**Review of the Rocky Flats Plant Special Exposure Cohort (SEC) Petition,
SEC-00030**

Supplemental Report on Neutron Doses at Rocky Flats, 1952 to 1970

**Contract No. 200-2004-03805
Task Order No. 5
SCA-SEC-TASK5-0052, Supplemental Report**

April 30, 2007

Figure 15: Percent Notional Dose compared to Total Neutron Dose Estimate, 1965

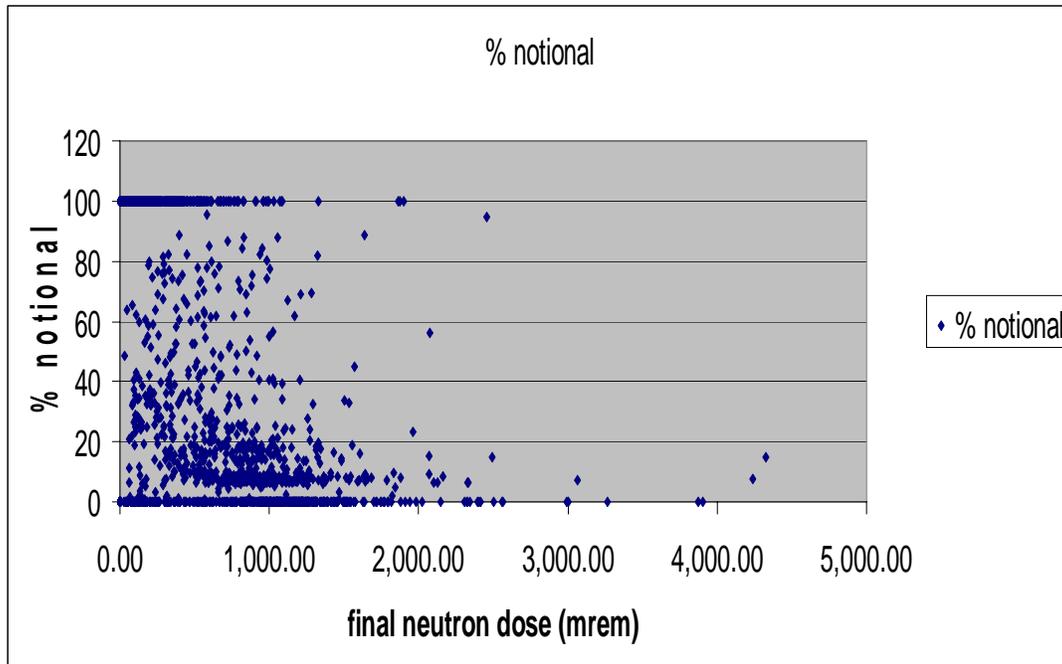
When many of the high dose estimates are 100% notional doses, it indicates that there may have been gaps in coverage of the more exposed workers in this period. As noted before, a conclusion based on a comparison of notional dose with measured dose (the 0% notional dose dots in the above figures) is of limited significance, due to the uncertainties in the n/p ratio method and some claimant-favorable features that may be in the notional dose estimate. Nonetheless, the contrast with 1965 is interesting, because the same comparison yields a different result. In that year, the highest estimated exposures were for those workers who have full-year or partial-year monitoring, while the ones with no monitoring generally had lower total estimated doses. This is shown in Figure 15.

Figure 18: Correction Factors versus Re-read Dose, 1969, with a Linear Regression Plot

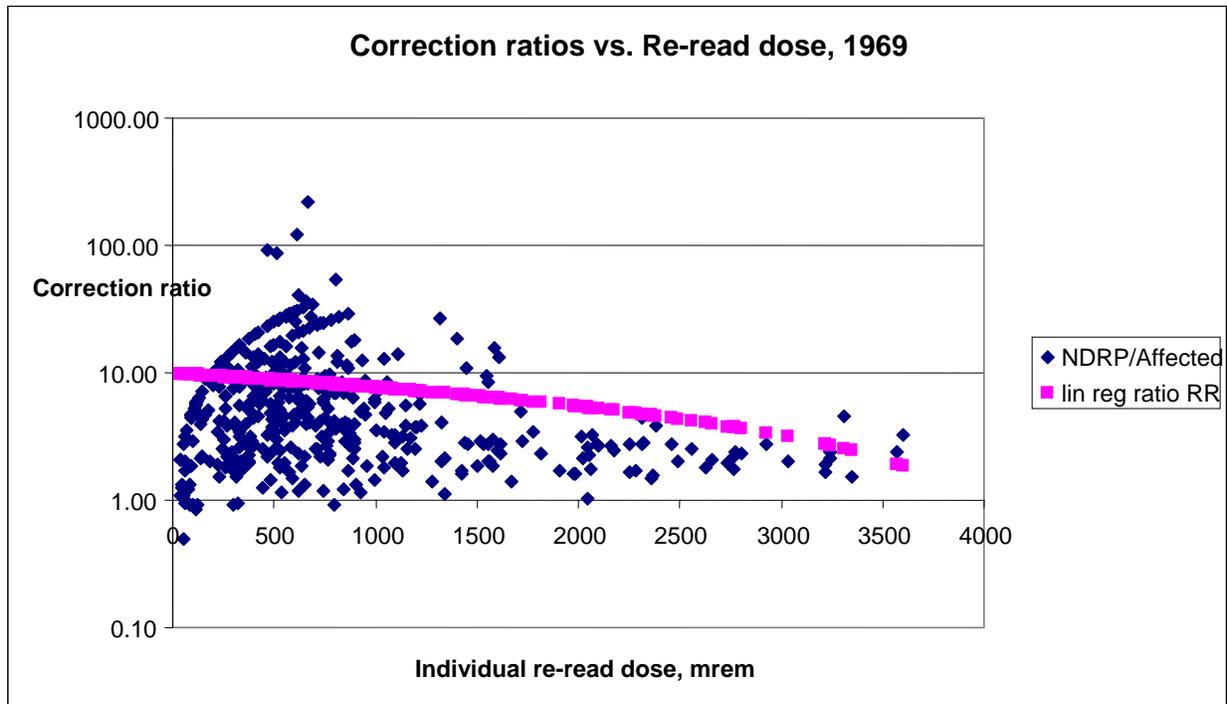
The data for 1969 point to a larger problem than one of finding a suitable correction factor for non-re-read doses for that year. First, the number of workers with non-read dose is large—605. Of these 605 workers, 438 had non-zero original doses that were re-read. The ratios of the re-read to the corresponding original doses vary from less than 1 in 11 cases (0.5 to 0.95 – i.e., the original doses were higher than the re-read doses) to 221, a variation of well over 2 orders of magnitude. More importantly, the correction ratios are not correlated with the re-read dose ($r^2 = 0.01$) and very weakly correlated with the corresponding original dose ($r^2 = 0.06$). Figure 18 shows the scatter plots and linear regression of the correction ratio versus the re-read dose (note the log scale on the vertical axis). The empirical lognormal mean of the ratios is 4.7 and the 95th percentile value is 22. The correlation does not improve significantly when the five highest values of the ratio are dropped ($r^2 = 0.03$).

A choice of a correction factor becomes problematic in this case. In theory, any number in the range of correction factors could apply to any original non-re-read dose. The potentially arbitrary nature of the correction raises issues of the scientific credibility of the result. Moreover, since hundreds of workers are involved, it would not suffice to use a 95th percentile correction factor, since that is likely to underestimate the corrected dose for some workers. A preliminary analysis by SC&A for 1970 indicates a result similar to 1969. Over 1,700 workers had non—re-read portions of their original neutron dose in that year.
